15-02

Onsite System Minimum Design Specifications

**Applicant** Ronnie Wolfe  
 6104 Pebble Creek Cove,  
 Floyds Knobs, IN 47119  
**Phone** 812-989-3532  
**Site Address** SR 11, N/A Floyds Knobs, IN 47119  
**Parcel ID#** N/A  
**Location Description:**  
 N/A

## INVENTORY AND EVALUATION OF SOIL RESOURCES

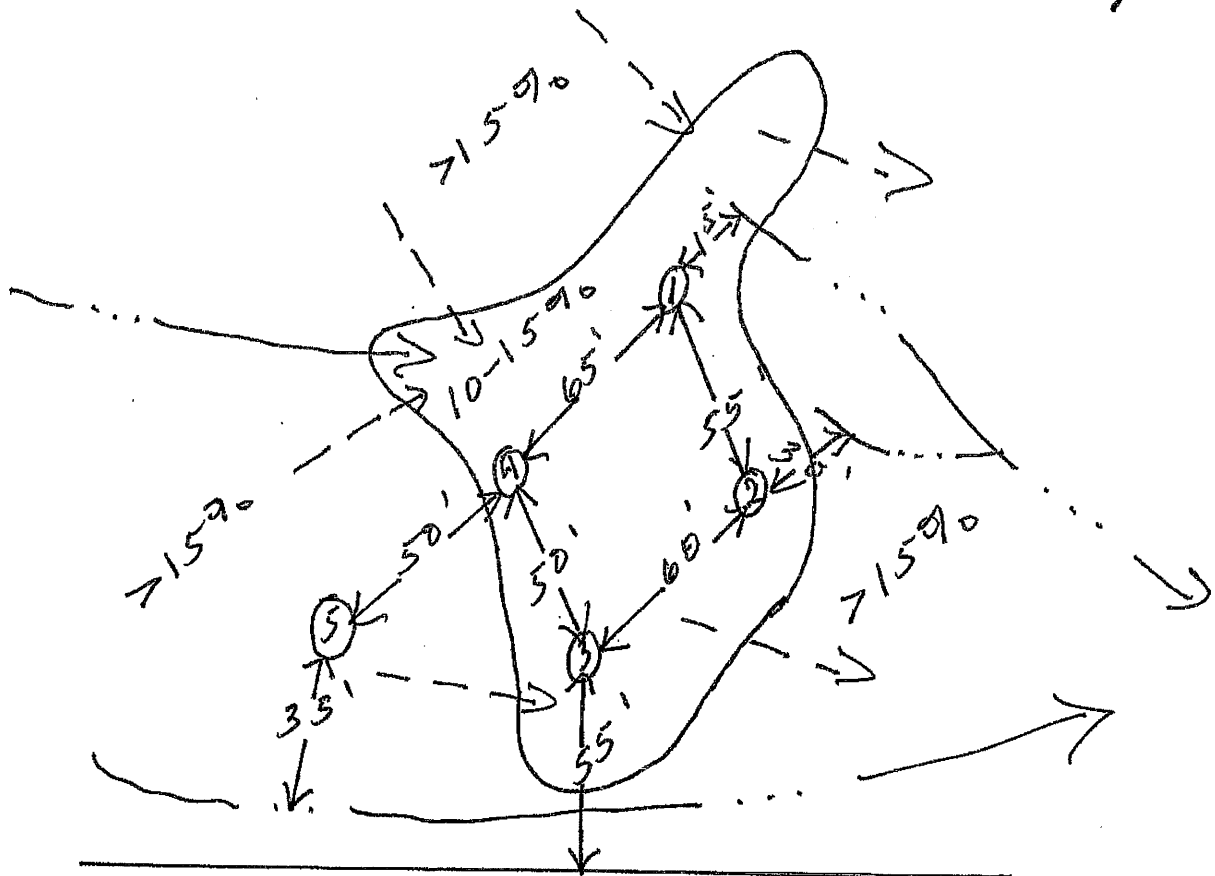
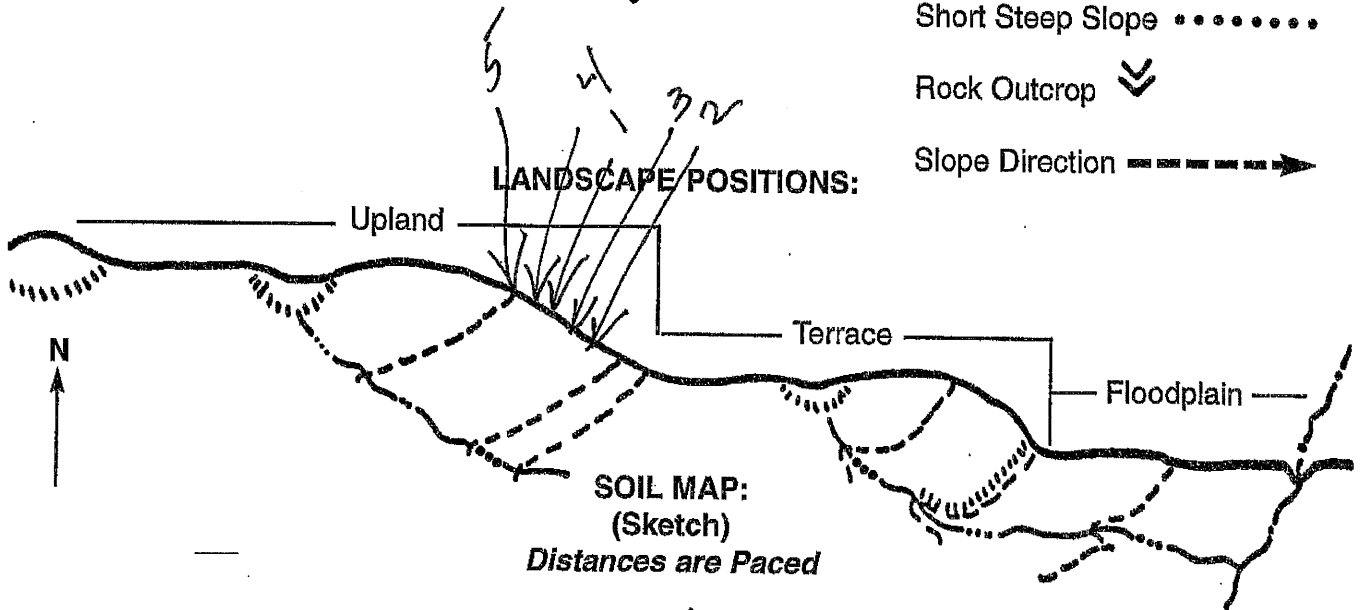
Primary System and Set-a-side to be design and installed over SB 1-4 and along contour. Site plan is required. System cannot be installed on slopes over 15%. System cannot be installed upslope of SB 3&4. Area of septic must be cleared prior to site survey. Septic cannot be installed in drainway/ intermittent stream. Protect area of septic during all phases of house construction.
